**Convention on Road Signs and Signals (1968)-
Group of Experts on Road Signs and Signals**

Final report

Submitted by the Group of Experts on Road Signs and Signals

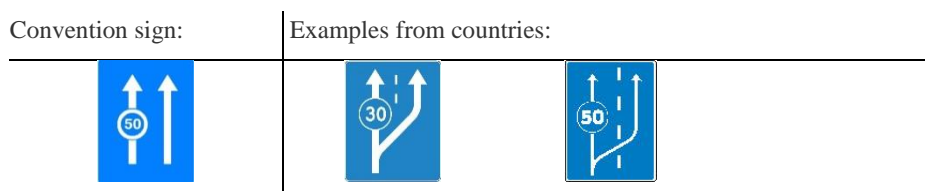
Albania, Croatia and Greece wrongly used examples for E, 1 a instead of E, 1 b.

Many countries use road markings (broken line) on this sign. The Group recommended the symbols on this sign not to include road markings ie., broken lines as the arrows indicate the “lanes”.

The Group recommended that for the E, 1 b sign the sign D, 7 is used with a white rim.

E, 1 c “SPEED LIMITS APPLYING TO DIFFERENT LANES”

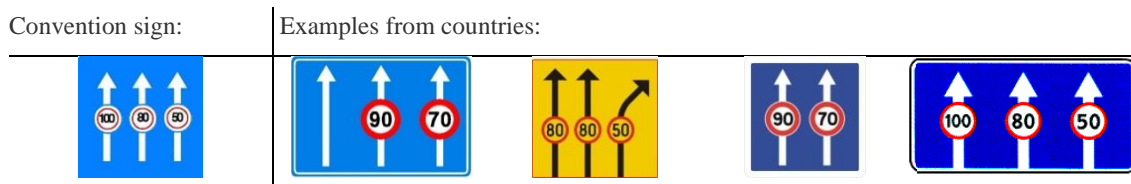
Azerbaijan used a wrong example for E, 1 c sign (truck entry prohibition sign instead of speed limit sign).

The Group recommended that the E, 1 c sign is improved by placing the sign C, 14 on the arrows and adding a white rim.

E, 2 a “SIGNS INDICATING LANES RESERVED FOR BUSES”

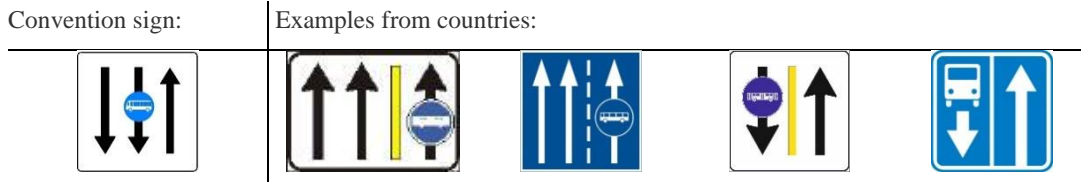
Several countries (Azerbaijan, Belgium, Croatia, Latvia, Luxembourg, Montenegro and Ukraine) use examples for E, 2a that do not correspond to the examples of the Convention.

Many countries use road markings (broken or continuous line) on this sign. The Group recommended the symbols on this sign not to include road markings as the arrows indicate the “lanes”.

Contracting Parties should note the recommendation for this sign in section 1.2 of this document.

E, 2 b “SIGNS INDICATING LANES RESERVED FOR BUSES”

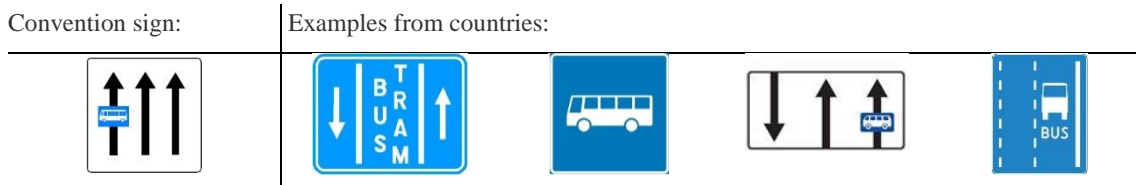
Several countries (Belgium, Croatia, Finland, Latvia, Montenegro, Poland and Ukraine) use examples for E, 2 b that do not correspond to the examples of the Convention.

Addressed in chapter 1 – issue 22.

E, 3 b “ONE WAY”

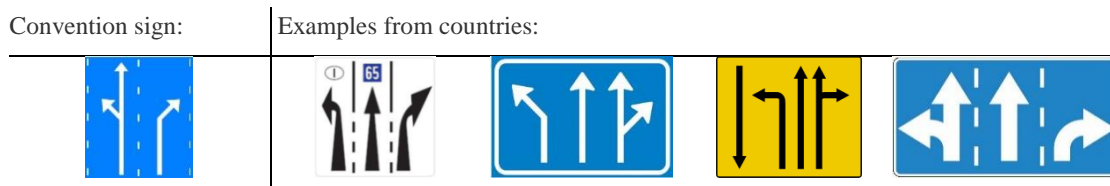
There are minor differences in shape of arrow heads, arrow tails, proportions of arrows within the sign. The Group recommended Contracting Parties to pay closer attention to the design details, in particular, to the shape of the arrow head (by making it wider to improve the legibility). The tail of the arrow should not touch the edge of the sign.

Addressed in chapter 1 – issue 37.

E, 18 b “STOPPING PLACE IN CASE OF EMERGENCY OR DANGER”

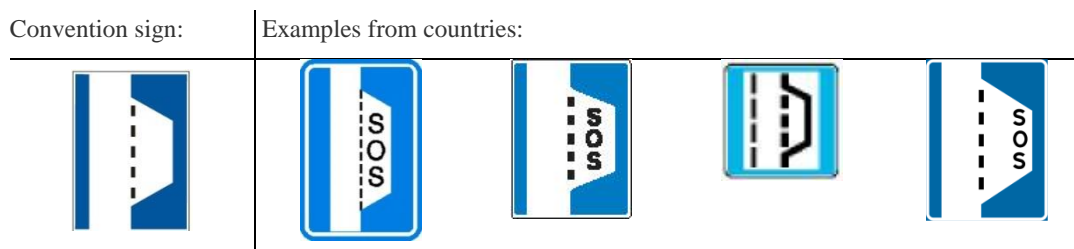
The Group noted that some countries (Belgium, Denmark, Finland, Netherlands, Portugal, Sweden and Switzerland) included the inscription S.O.S in the sign, which the Group considers to be in conformity with the Convention. The sign from Serbia contains the inscription S.O.S on the red square, which the Group considers not to be in conformity with the Convention.

The Group also noted that the sign from Germany has a different design, which appears to be a combination of E, 18 a and E, 18 b designs, which is considered not to be in conformity with the Convention.

G, 11a, 11b, 11c, 12a and 12b Signs indicating the number and direction of traffic lanes

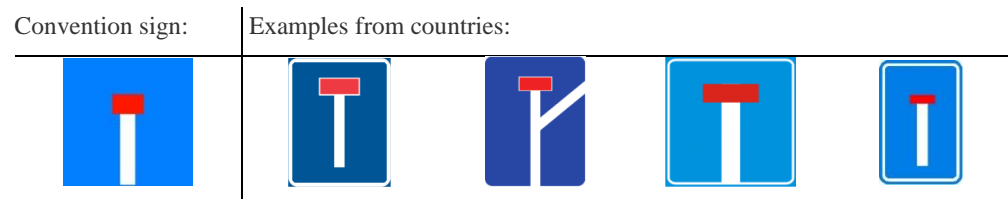
1. The Group noted that some countries used different colours for the ground and symbol (i.e. blue/green ground and white symbol) in addition to the white ground and black symbol for the Convention sign. In this regard, the Group noted that the Convention did not specify what colours are permitted for this sign. However, it did note that the Convention specified that the use of orange symbols may be used for temporary indication signs. Addressed in in chapter 1 – issue 36

Addressed in chapter 1 – issue 11, 12 and 31.
